RESPONSE TO COMMENTS
&
FINAL DECISION

REMEDIAL ACTION DECISION DOCUMENT (RADD)

Former Cedar Chemical Facility
Intersection of U.S. Highway 49 & Highway 242
Helena-West Helena
Philips County
Arkansas

AFIN: 72-00174

Figure 3

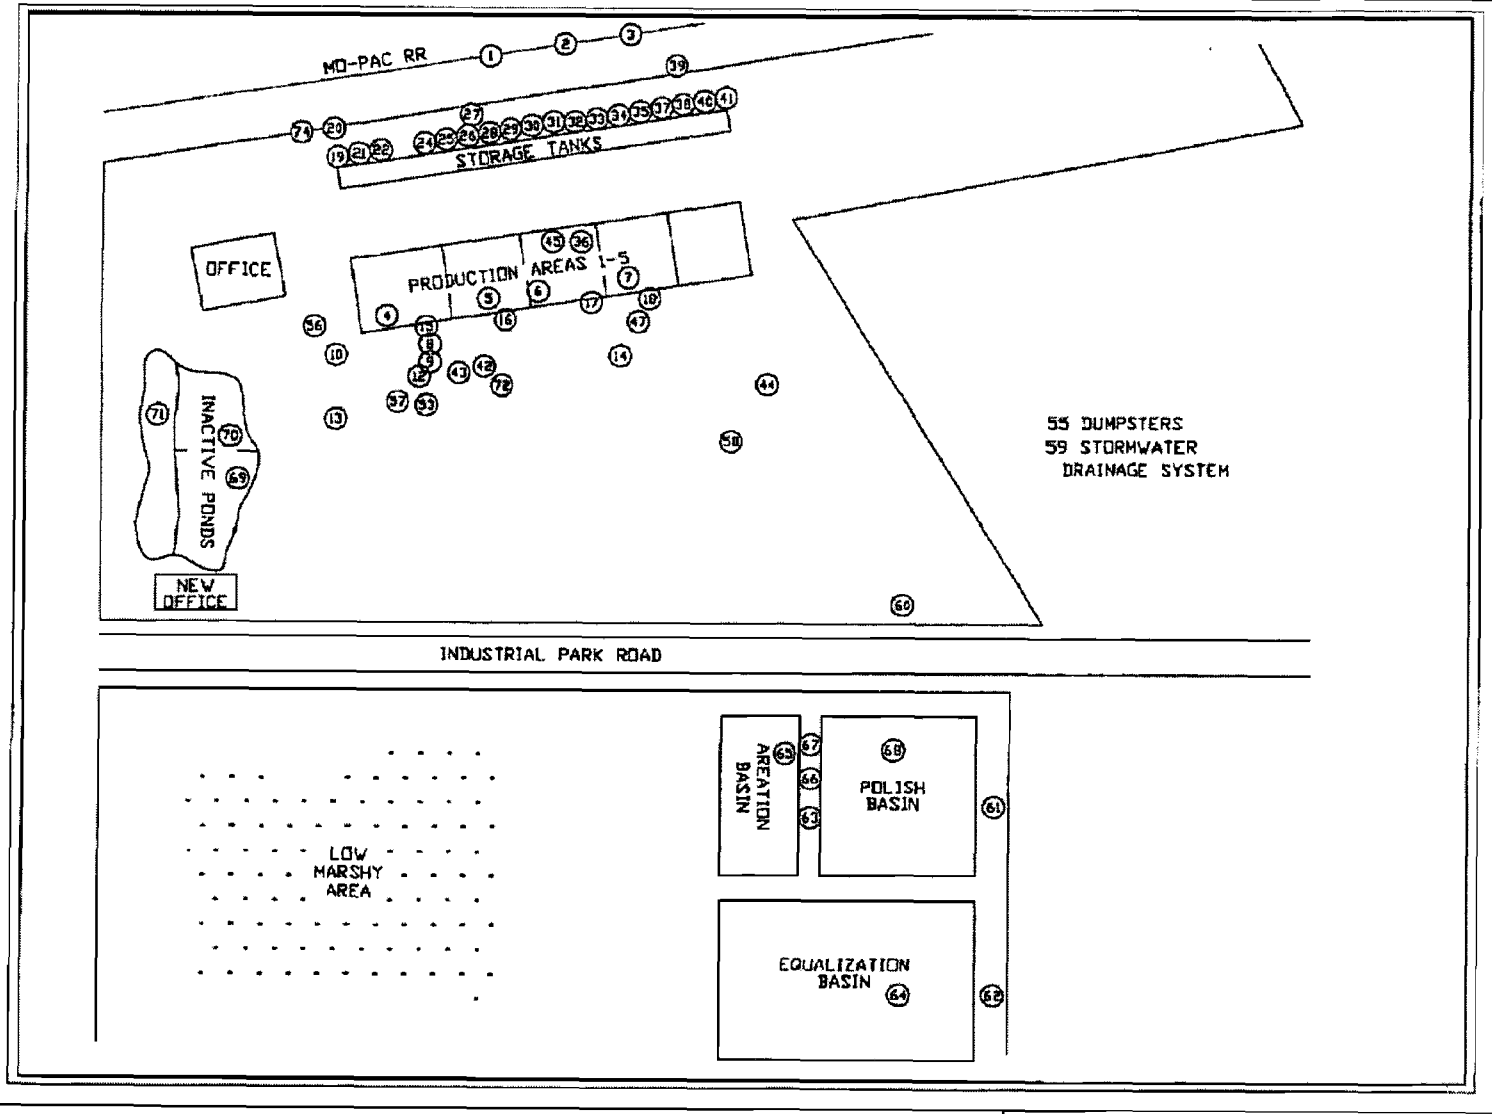
Comment No. 6)
Summary of Remedial Approach, p. 6, par. 2: ADEQ references "previous investigations" for its Table 1. ADEQ should provide the title and date of the investigation reports that it is relying upon for the information provided in Table 1 and Figure 3.

Response*: The source of information is located in the title of Table 1 and in the title block of Figure 3. Therefore, no change to the final RADD is warranted.*
